# Central Falls High School

## 100% Construction Documents

Ai3 Project #2202.02

### **Addendum #3**

7 INTERIOR WALL SECTION  
3/4" = 1'-0"

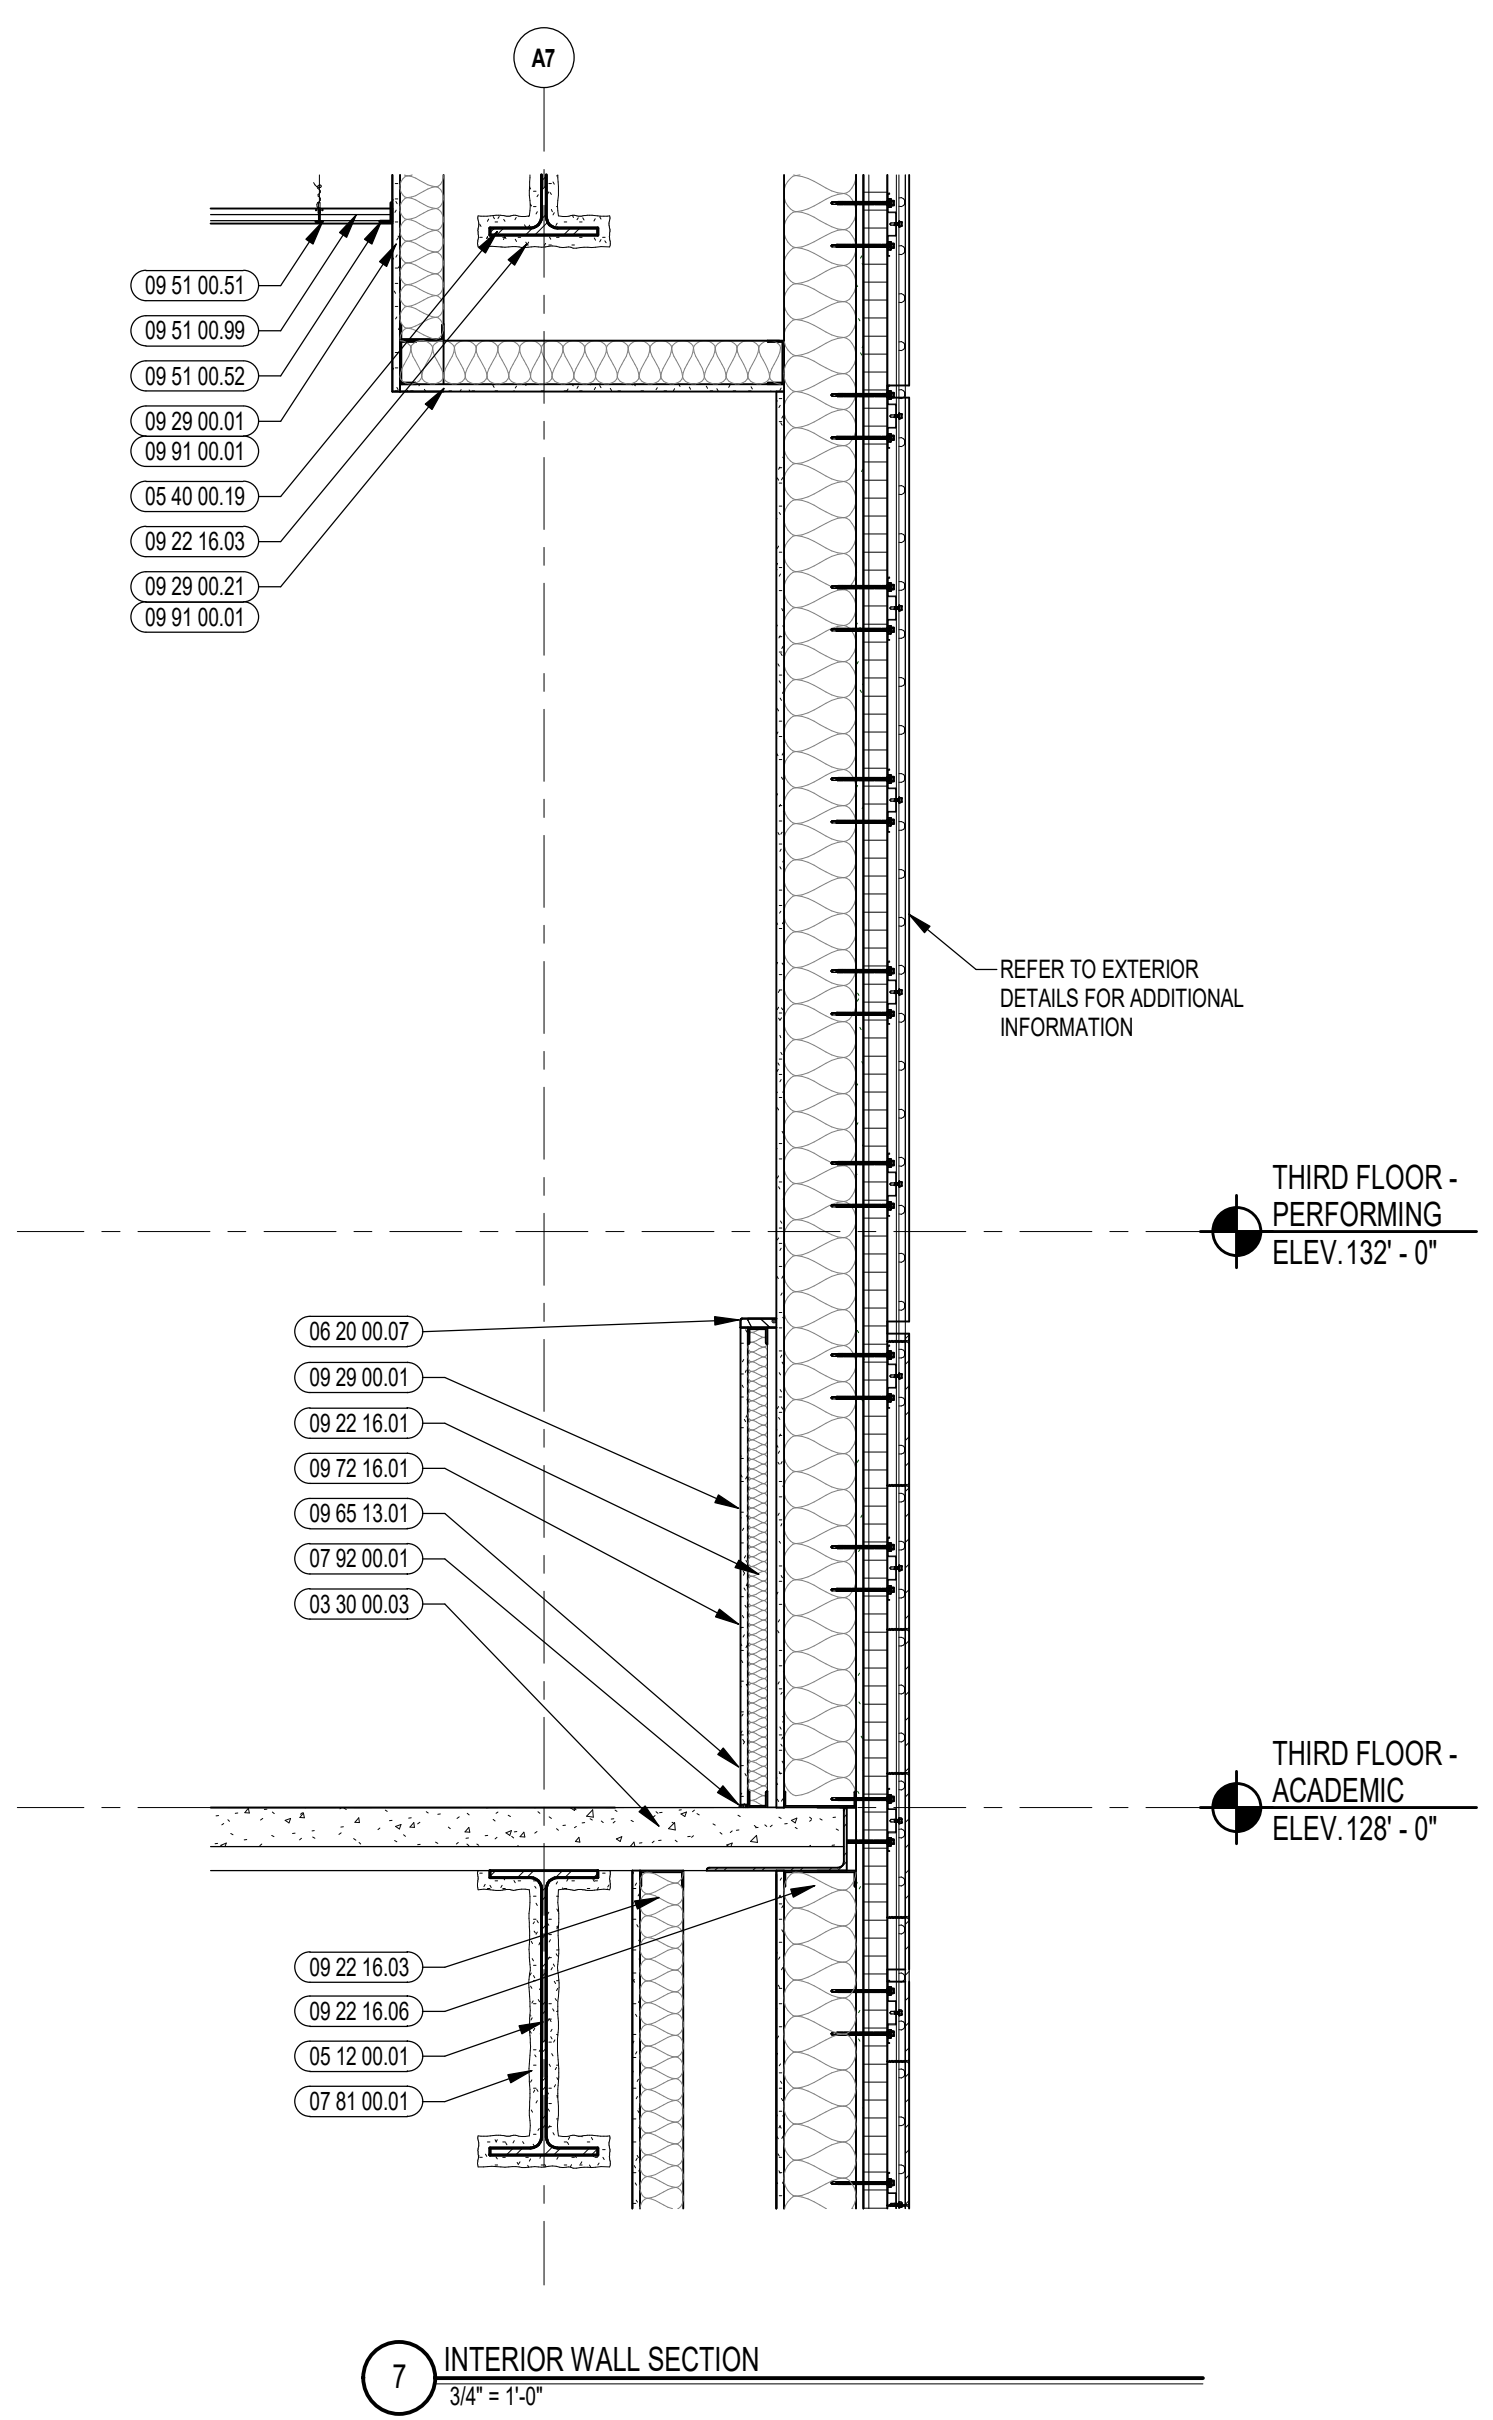
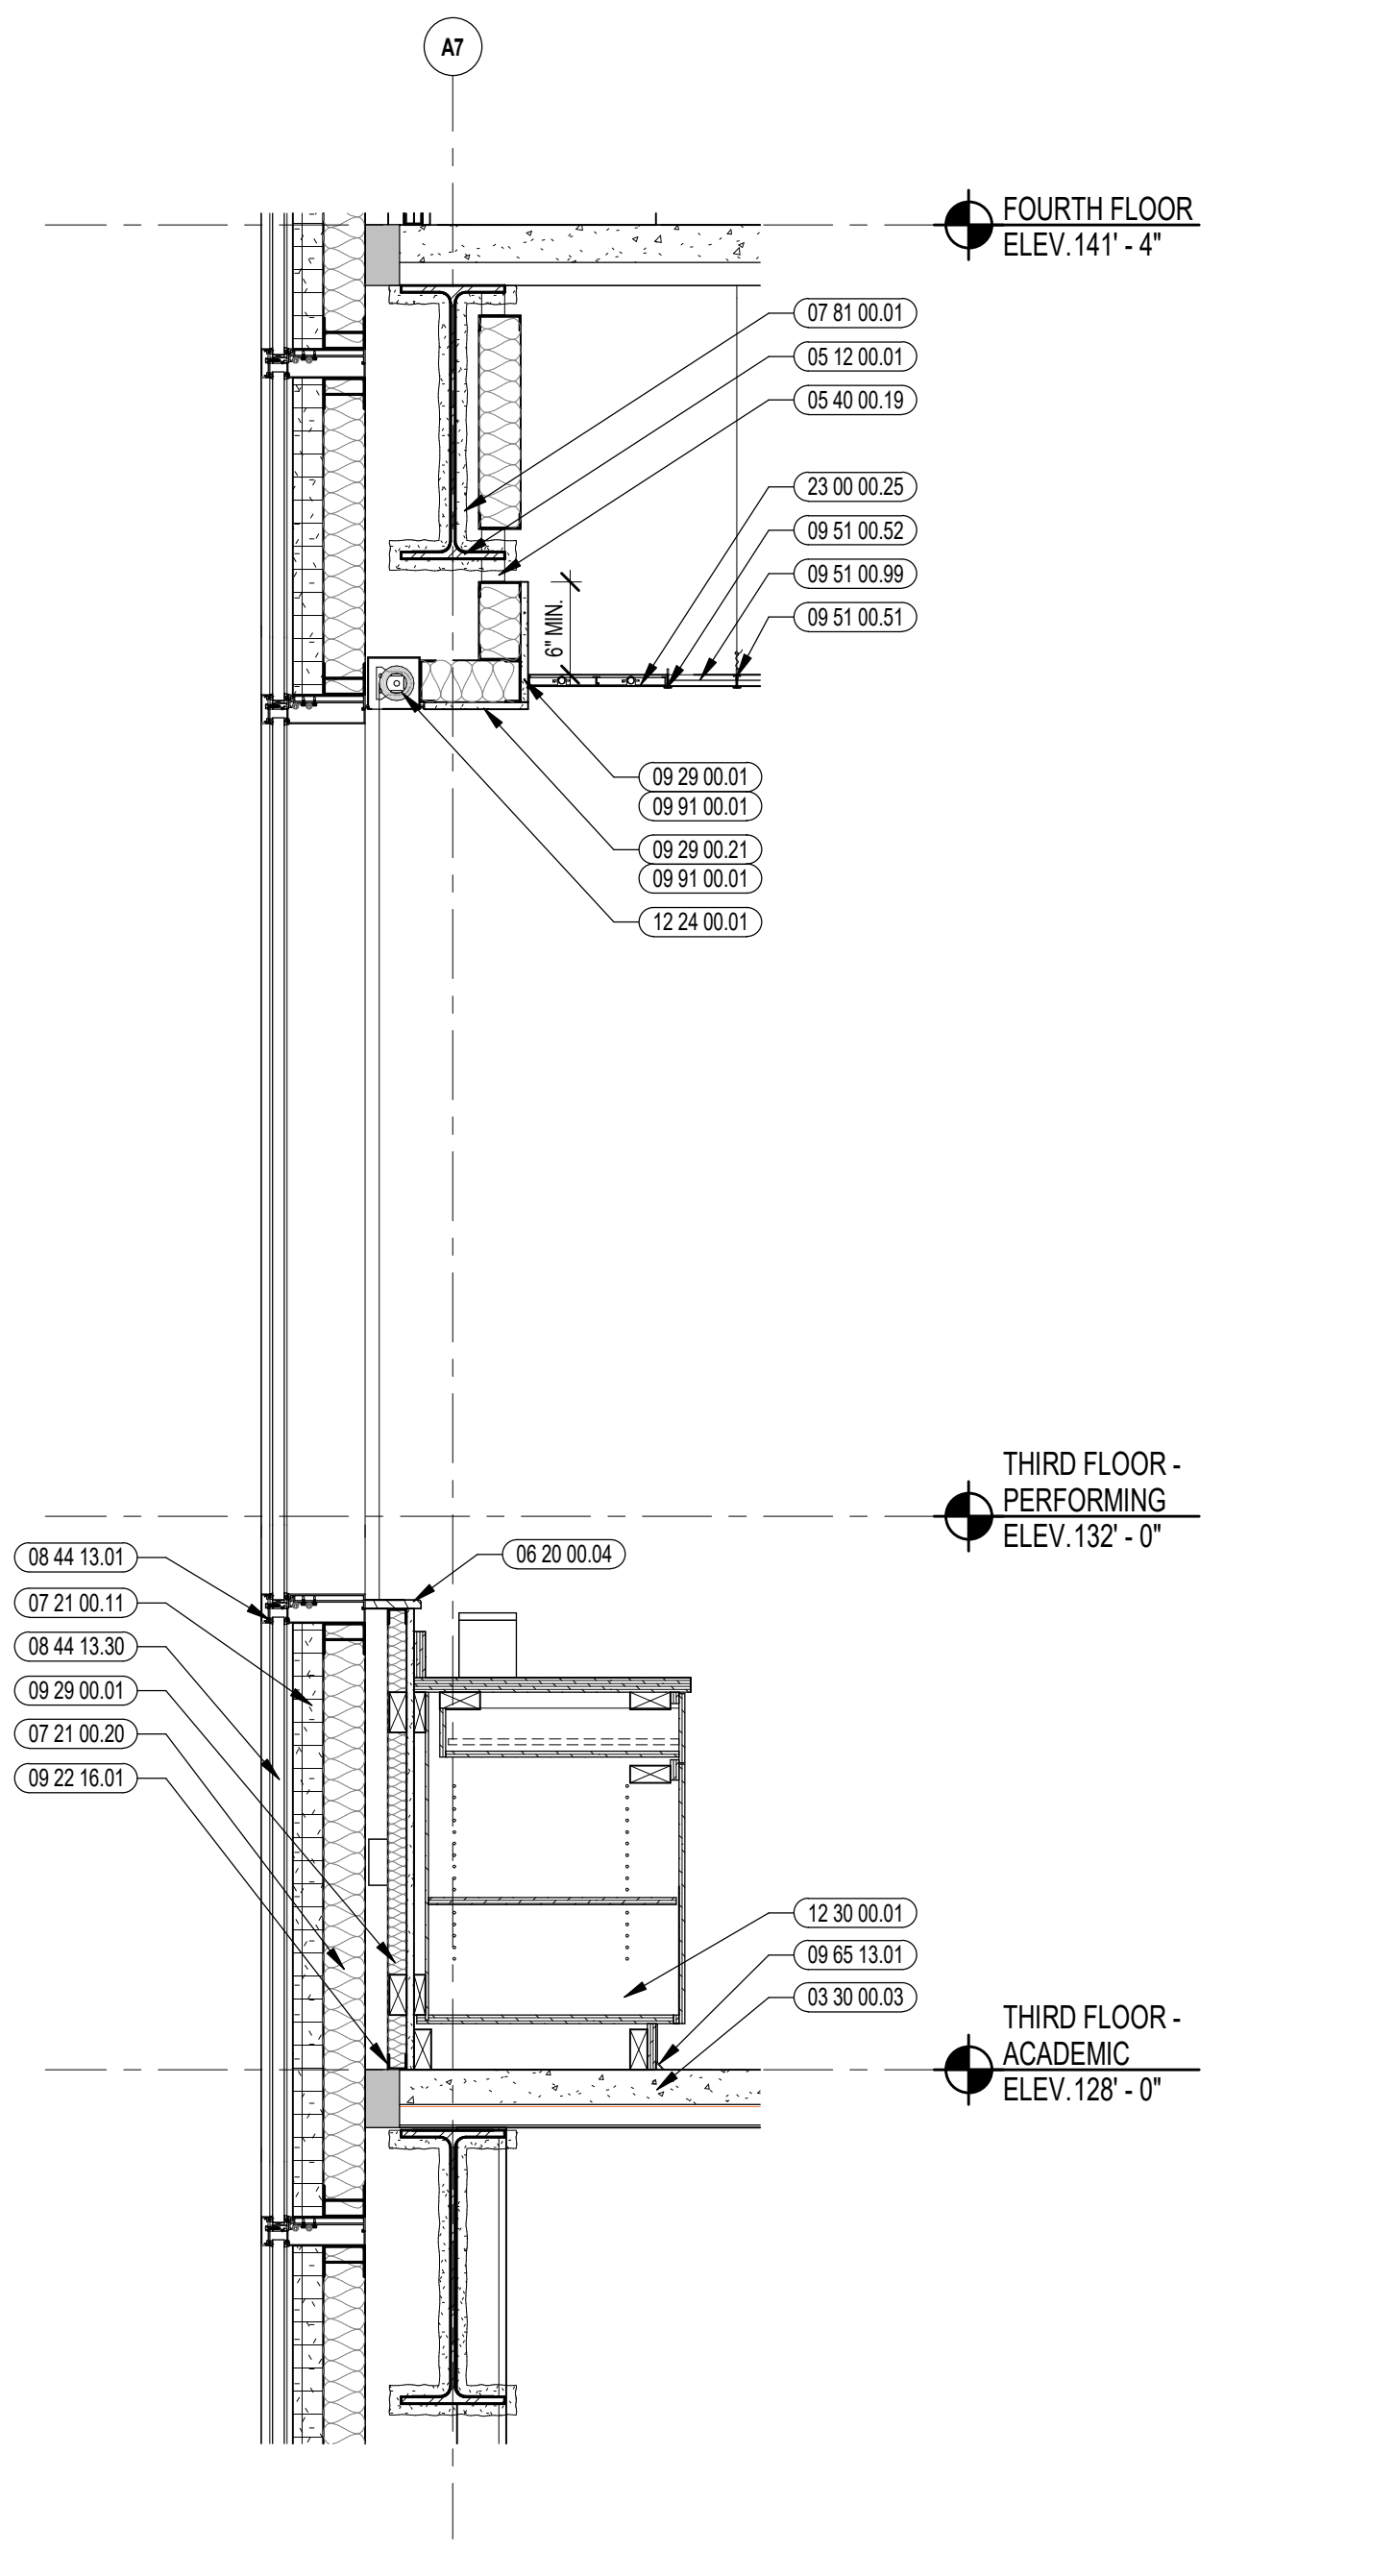
**ADD 3-002** **Bidder Question:** There doesn't seem to be drawings with Window Shade (Section 12 24 00) locations or any notes of the shades on the finished plans. The specs under part 2.1, they state there are roller shades manual, dual roller shades manual, blackout shades manual, and blackout shades motorized with locations for the blackout shades manual and blackout shade motorized. Where are these located? **Response:** Refer to opening details, interior wall sections, enlarged floor plans and elevations for keynoted shade

locations. See additional clarifications on A7.73, A9.25A, A10.20C and A10.41 in Addendum #3.
